May 29, 2001  
NG-01-0721

Subject: Duane Arnold Energy Center  
Docket No: 50-331  
Op. License No: DPR-49  
Response to Request for Additional Information (RAI) to Technical  
Specification Change Request TSCR-042 – Extended Power Uprate. (TAC  
# MB0543)  
Reference: NG-01-0660, "Response to Request for Additional Information (RAI) to  
Technical Specification Change Request TSCR-042 – Extended Power  
Uprate. (TAC # MB0543)," dated May 11, 2001.  
File: A-117, SPF-189

**Redacted Version of**  
**DAEC Responses to NRC**  
**Containment Systems Branch**  
**Request for Additional Information**  
**Regarding Proposed Amendment for Power Uprate**

**Figure 1: Containment Pressure Response For Short-Term DBA LOCA**

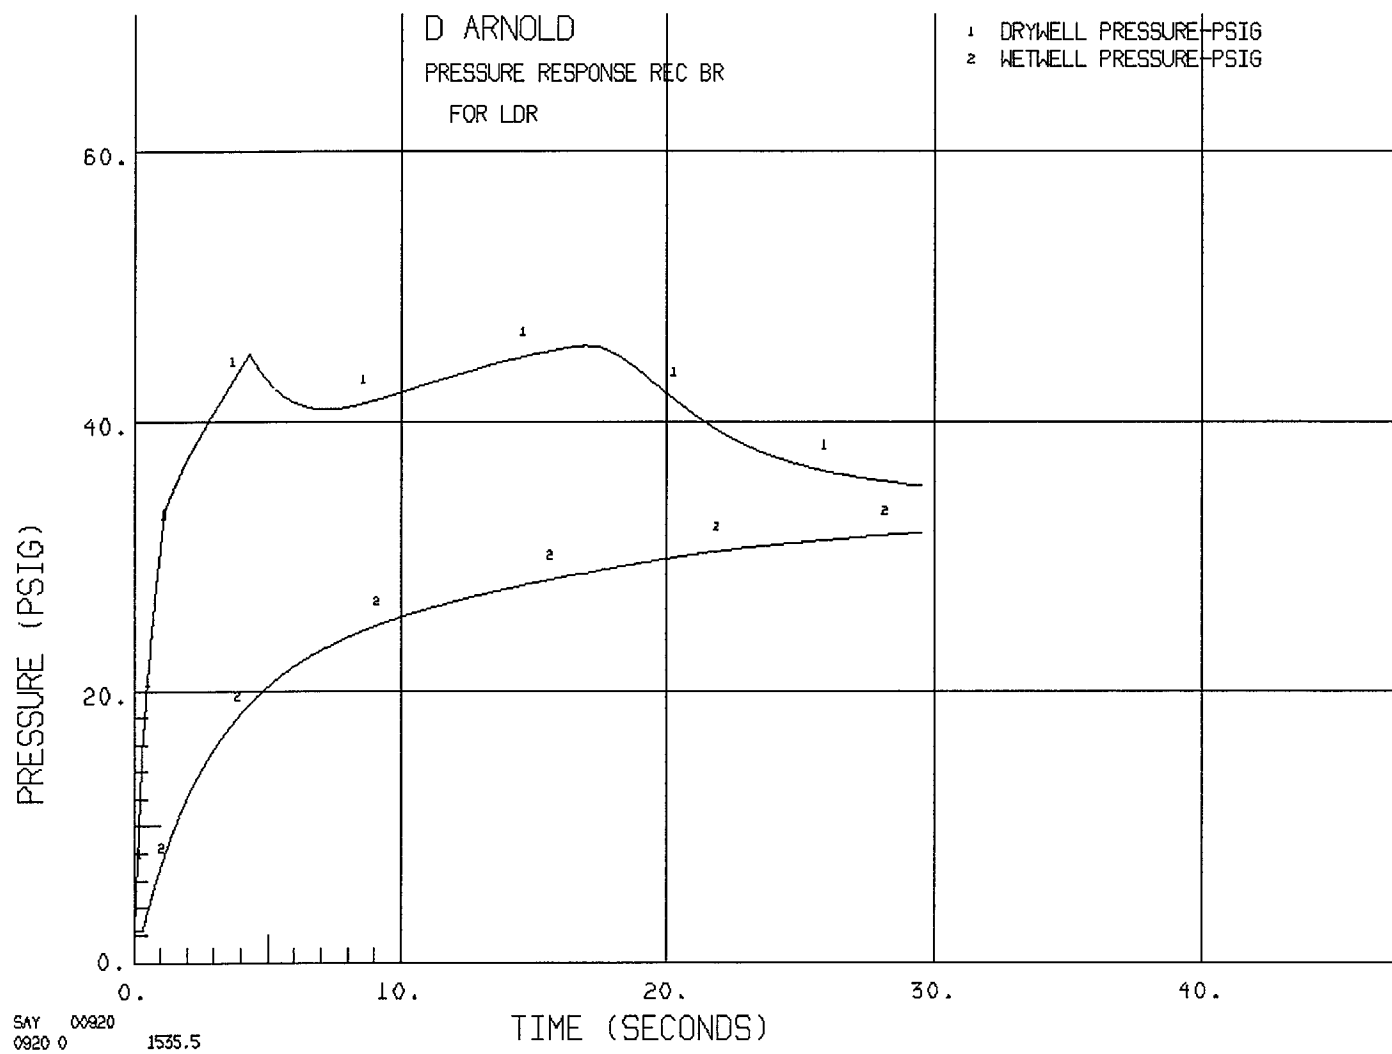
3. Provide short term and long term results (curves or tables of calculated values as a function of time) of Duane Arnold calculations for:

- (A) drywell short term pressure and temperature,
- (B) suppression pool short term temperature
- (C) wetwell atmosphere short term pressure and temperature
- (D) suppression pool long term temperature
- (E) wetwell atmosphere long term pressure and temperature

- (A) Short-term drywell pressure – Figure 1  
Short-term drywell temperature – Figure 2
- (B) Short-term suppression pool temperature – Figure 2\*
- (C) Short-term wetwell atmosphere pressure – Figure 1  
Short-term wetwell atmosphere temperature – Figure 2\*

**Figure 6: Containment Pressure Response For Long-Term NPSH**

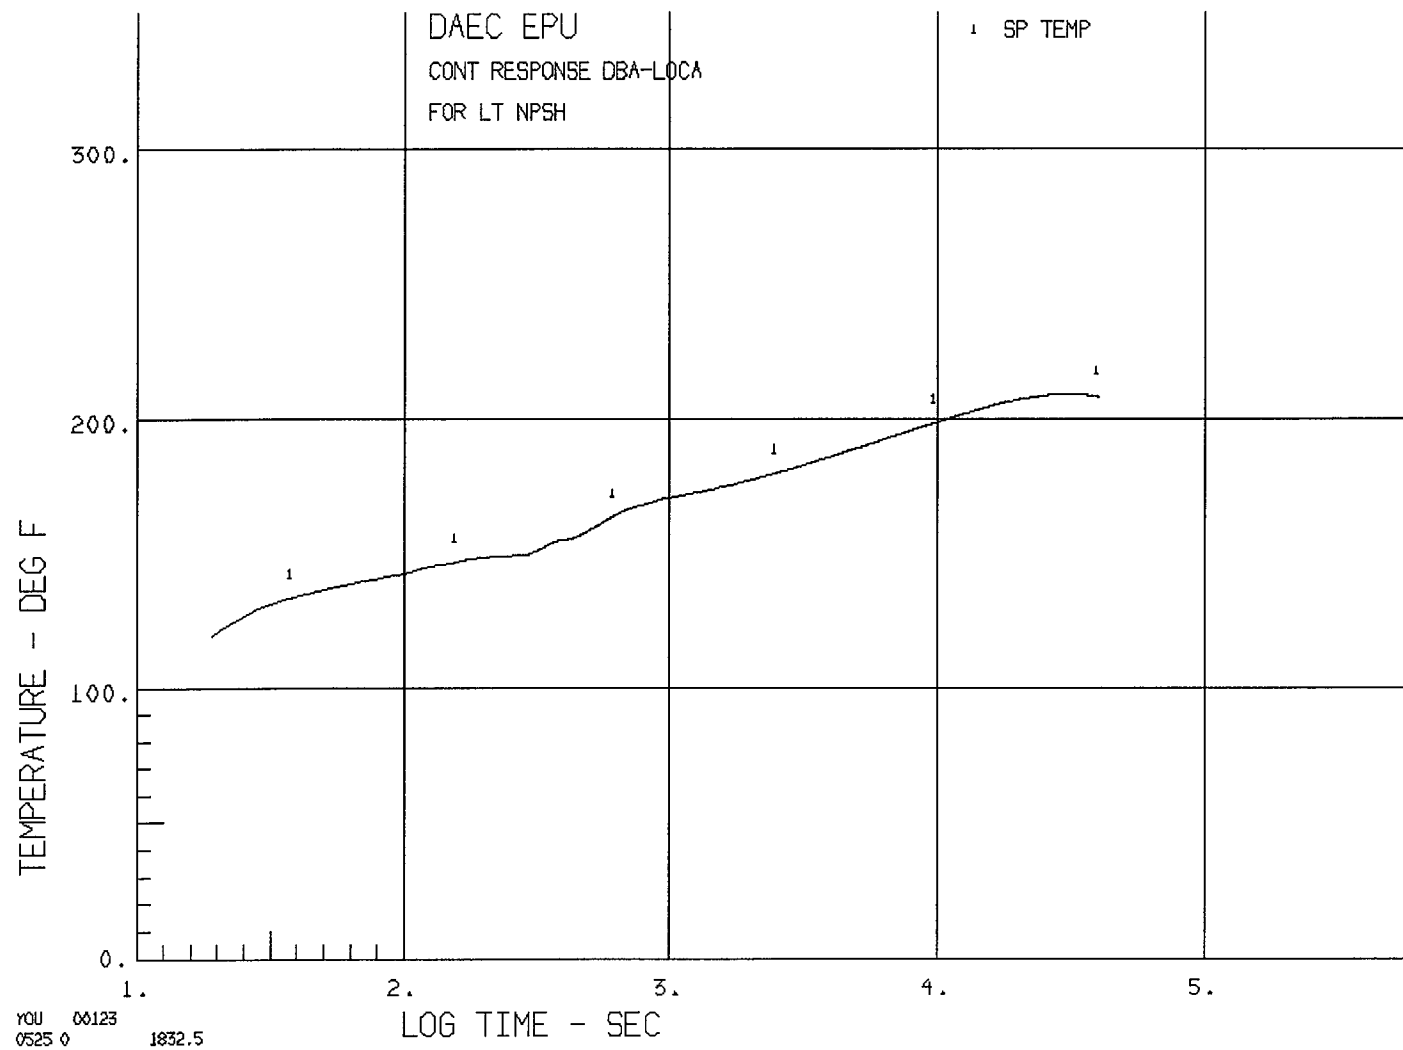
If the long term calculation results are different from those used for calculating NPSH, provide the suppression pool long term temperature and wetwell atmosphere long term pressure and temperature used for the NPSH calculation.

- (D) Long-term suppression pool temperature:
  - DBA-LOCA - Figure 5
  - NPSH - Figure 8
- (E) Long-term wetwell atmosphere pressure
  - DBA-LOCA - Figure 3
  - NPSH – Figure 6

**Figure 11: Drywell Airspace Temperature Response For 0.01 ft<sup>2</sup> Steam Line Break (Beyond 1 Day)**

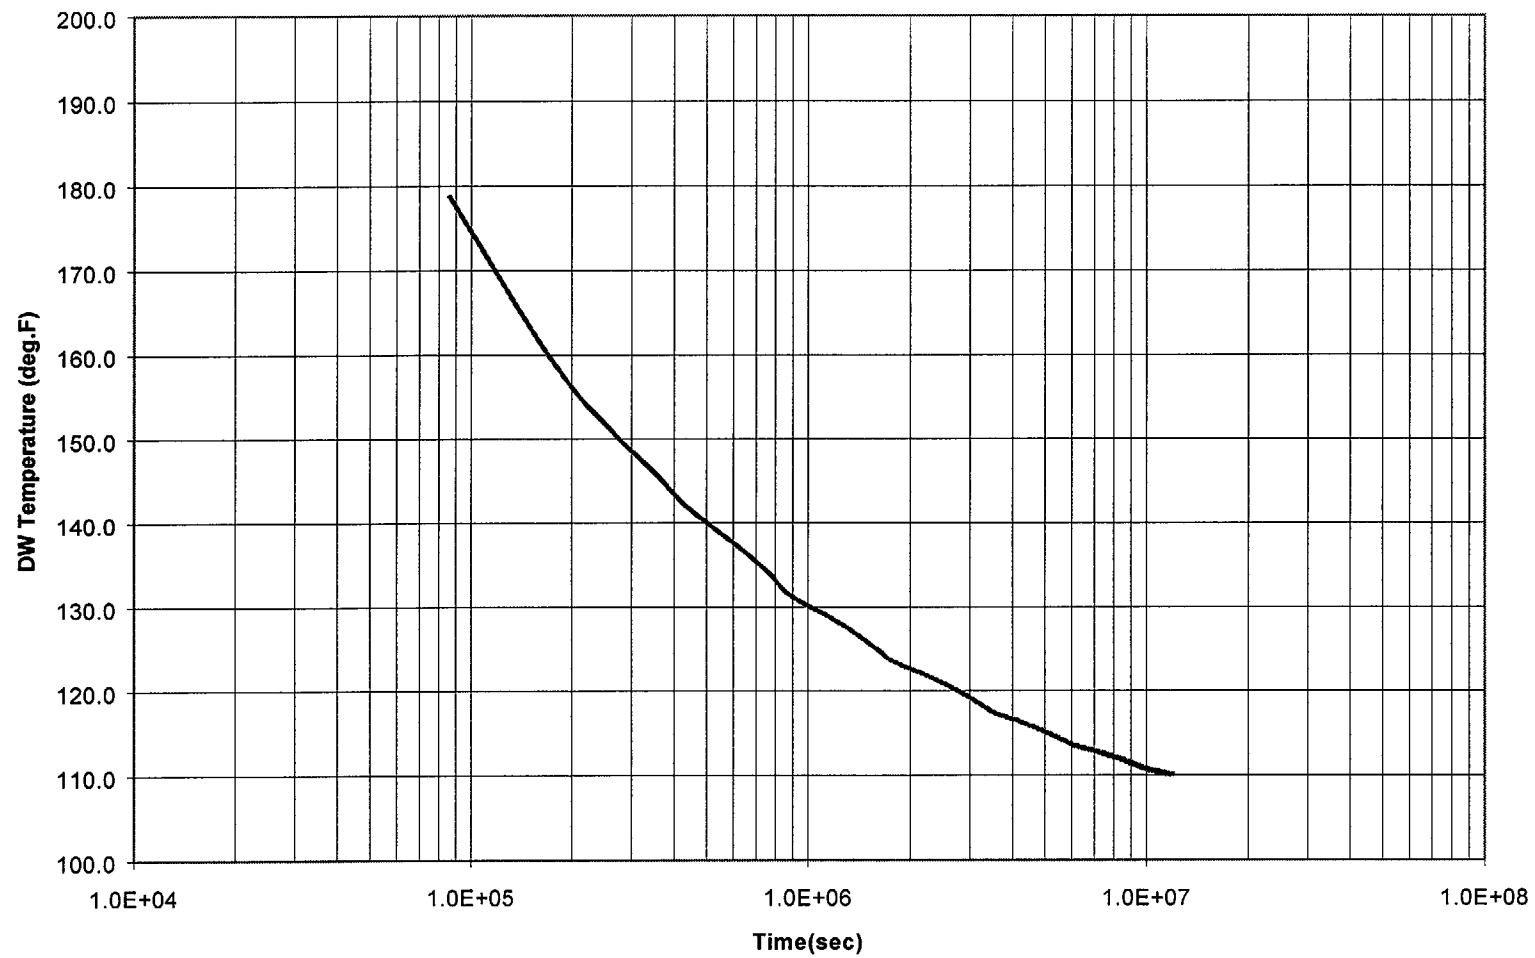
In addition, based upon the conference call with the Staff, a representative main steamline break should be included in the data request. Consequently, we are also providing the following figures of the results of that analysis:

- (F) Drywell and wetwell atmosphere pressure – Figure 9  
Short-term Drywell temperature – Figure 10  
Long-term Drywell temperature – Figure 11  
Wetwell atmosphere temperature – Figure 12  
Suppression Pool temperature – Figure 13
